RAI 03.07.02-24, Supplement 1, Revision 1**QUESTION:****Follow-up Question to RAI 03.07.02-15 (STP-NRC-100036)**

UHS Basin and RSW Pump House:

RSW Piping Tunnel:

Figure 3H.6-138: RSW Piping Tunnel, Horizontal Response Spectra

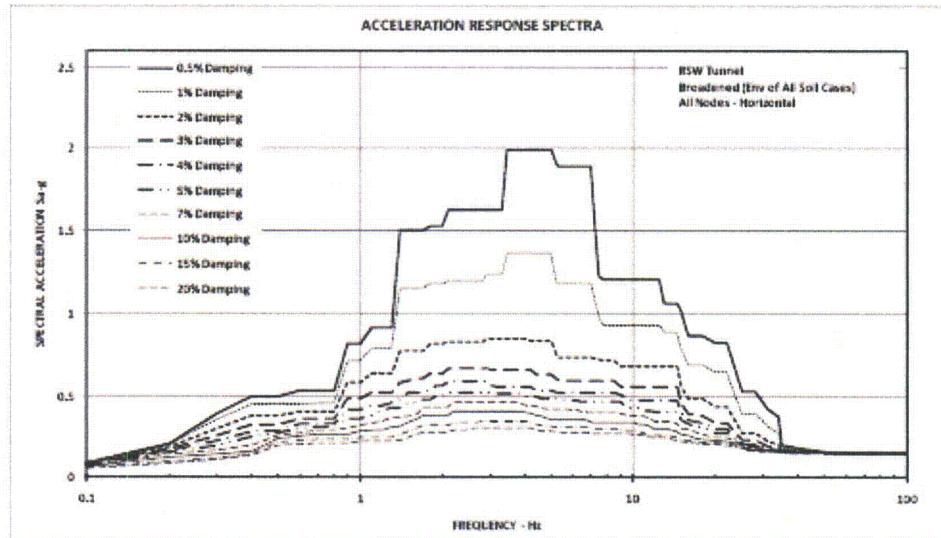
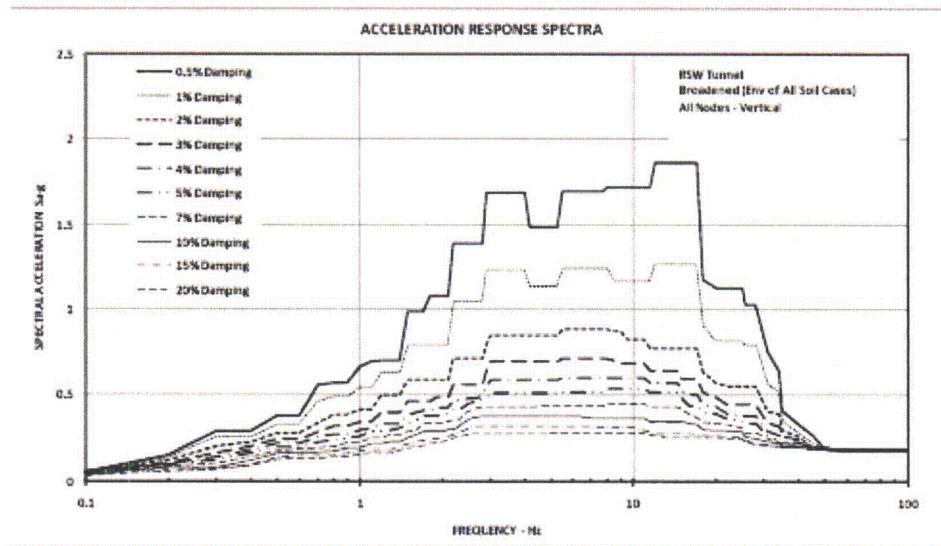
1. In the response to Item 1 of RAI 03.07.02-15, the applicant has stated that a 2D SSI analysis of the RSW tunnel has been performed to quantify the in-structure response of the tunnel. No details of this analysis have been provided. As such, the applicant is requested to describe in sufficient detail in the FSAR how the SSI analysis of the RSW tunnel has been performed. The description shall include the SSI methodology, figures showing the SSI model and boundary conditions, summary of the soil and structure properties, the input motion, etc. so the review can be completed.

- Envelope of the resulting response spectra for the base slab, intermediate floors and the roof slab are shown in revised COLA Part 2, Tier 2 Figures 3H.6-138 and 3H.6-139, which are used as the design in-structure response spectra for the RSW Piping Tunnel.

Figure 3H.6-210: SSSI 2D Model of RB + RSW Piping Tunnel + RWB

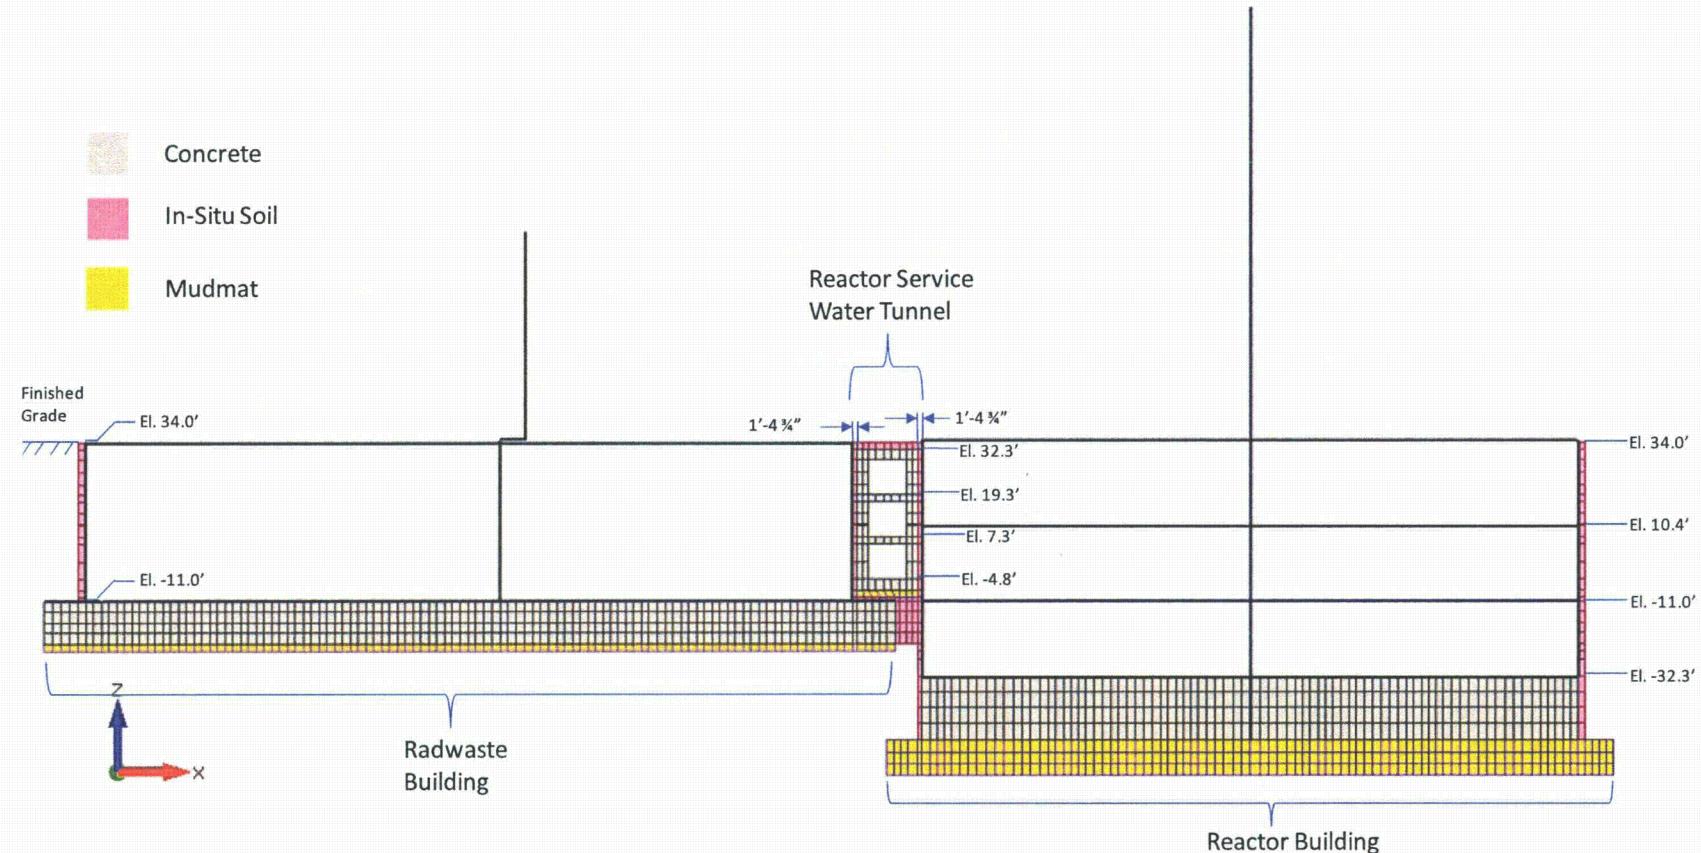
2. In the response to Item 2 of RAI 03.07.02-15, the applicant has stated that simple manual calculations were used for the analysis and design of individual components of the RSW piping tunnel. For this analysis, the tunnel walls, slabs and base mat are considered as rigid elements, and seismic loads are calculated based on a ZPA of 0.21g. The applicant further states that the analysis did not include any model or soil springs; the seismic loads are applied in terms of dynamic soil pressures on the exterior walls, calculated as per ASCE 4-98 recommendations. Staff has not endorsed ASCE 4-98 recommended dynamic soil pressures for design of tunnel walls. As such, the applicant is requested to provide comparisons of the dynamic soil pressures on the RSW tunnel walls calculated using 2D SSI model versus those of ASCE 4-98 to demonstrate that the design pressures are still bounding when the effects of kinematic interaction between tunnel structures and surrounding soils as well as the effects of structure-soil-structure interaction (SSSI) due to nearby heavy structures are considered.

Figure 3H.6-210 shows the structural part of the 2D plane-strain model of RB + RSW Piping Tunnel + RWB. Specifics of this SSSI analysis are as follows:
